# Access Compliance Report

## Public Rights-of-Way

Intersection ID: 29709	Main Street: COLE_MILL_RD	Cross Street: LUTHERS_ROCK_CT	Location: S
ADA ID: 91F0885189CC	Ramp Type: PerpDiag	Initial Pass/Fail: Fail	Overall Compliance: No
Severity Score: 21.25			
Codes/Mitigation Info/Possible Solution		Field Measurements/Component Compliance

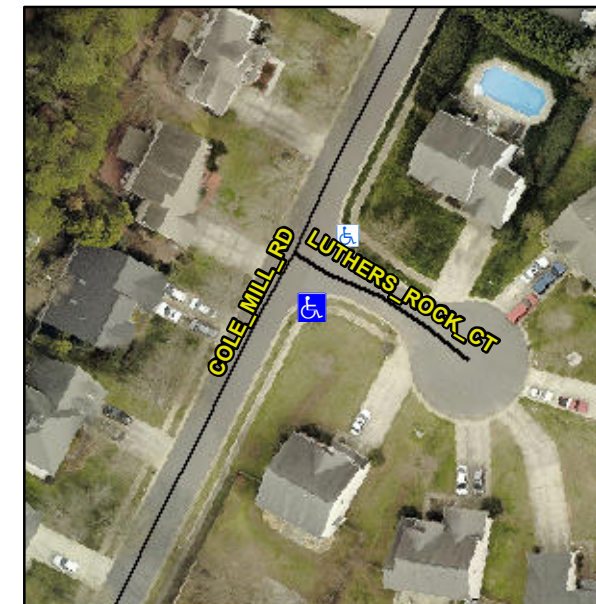
**Remove & Replace Curb Ramp With Two New Directional Ramps or Equivalent.**

**R304.5.1, R304.5.3**

Compliance	Description	Data	Compliance	Description	Data
N/A	Ramp Length (in)	49.0	Yes	Ramp Slope (%)	5.1
No	Ramp Width (in)	47.0	No	Ramp XSlope (%)	5.7
N/A	Flare Type LT	N/A	N/A	Flare Type RT	N/A
N/A	Flare Slope LT (%)	N/A	N/A	Flare Slope RT (%)	N/A
N/A	Flare Traversable LT?	N/A	N/A	Flare Traversable RT?	N/A
N/A	Landing Length (in)	N/A	N/A	DWS Provided?	N/A
N/A	Landing Width (in)	N/A	N/A	DWS Contrast?	N/A
N/A	Landing Slope (%)	N/A	N/A	DWS Length (in)	N/A
N/A	Landing X Slope (%)	N/A	N/A	DWS Full Width?	N/A
N/A	Landing Curb? (Y/N)	N/A	N/A	DWS Offset (in)	N/A
N/A	Shared Landing?	N/A			
N/A	Gutter Ponding?	N/A	N/A	Gutter Slope (%)	N/A
N/A	Gutter Lip Ht (in)	N/A	N/A	Gutter X Slope (%)	N/A
N/A	Painted X Walk1?	No	N/A	Painted X Walk2?	No
	X Walk 1 Direction	To NE		X Walk 2 Direction	To NW
N/A	X Walk 1 Width (in)	N/A	N/A	X Walk 2 Width (in)	N/A
	X Walk 1 Slope (%)	2.6		X Walk 2 Slope (%)	5.2
	X Walk 1 X Slope (%)	1.7		X Walk 2 X Slope (%)	2.8
